Addendum to the
Environmental Impact
Assessment Report

NISA
North Irish Sea Array

Chapter 34

Major Accidents and Disasters

Diagram A34.1 Highlights of observed climate change for Ireland and Fingal (Source: Fingal County Council Climate Change Action Plan 2024-2029)

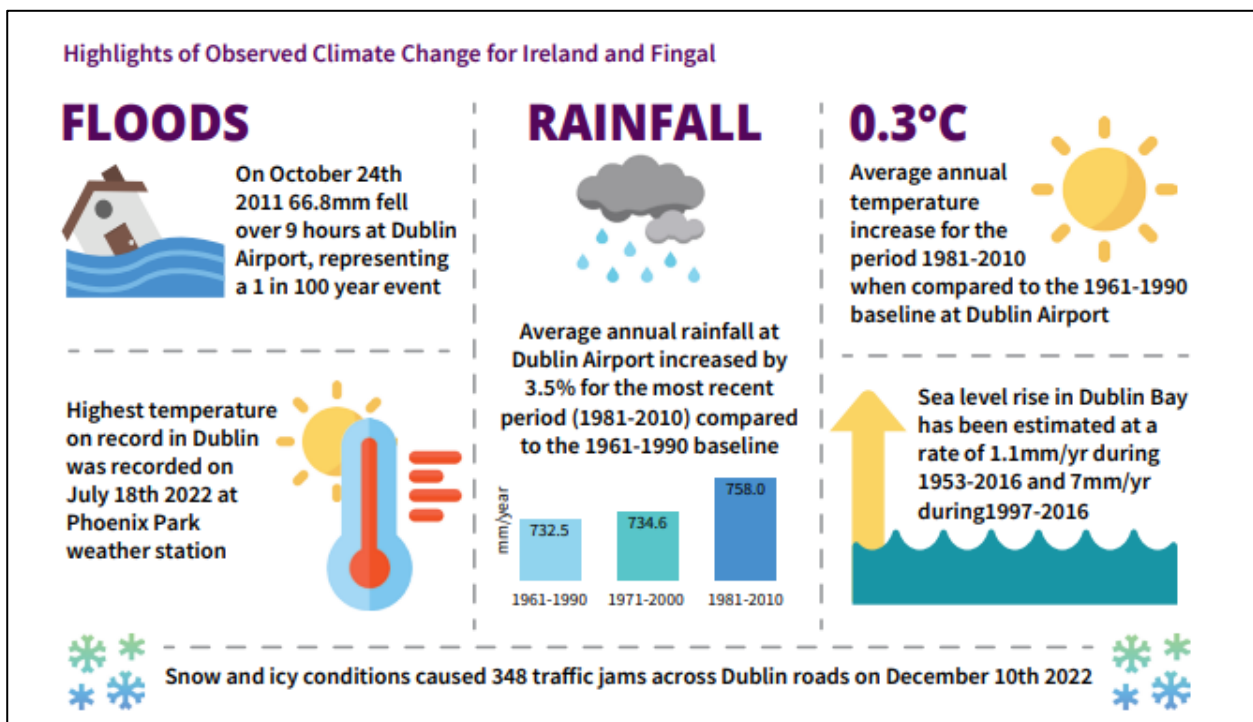
In response to RFI Section 1 (b), a review of relevant legislation was undertaken. The change required to this section is updating the references to the relevant County Council’s Climate Change Action Plans and the diagrams from the Fingal and Dublin City Council Climate Change Action Plans. Diagram 34.1 is deleted and replaced with Diagram A34.1 and A34.2, and the reference number for Diagram 34.2 is changed to A34.3 with “draft” removed from the title in reference to Louth County Council Climate Action Plan 2024-2029).

There has been a recent increase in the number of severe weather events in Ireland, including those leading to flash flooding, snow, both lower and higher temperatures than usual and strong winds. Highlights of observed climate change for Fingal and Dublin City, and an historic timeline of severe weather events in Meath and Louth as noted in the Fingal County Council Climate Change Action Plan 2024-2029, the Dublin City Council Climate Change Action Plan 2024-2029, the Meath County Council Climate Action Plan 2024-2029 and the Louth County Council Climate Action Plan 2024-2029, are presented in Diagrams A34.1, A34.2 and A34.3.
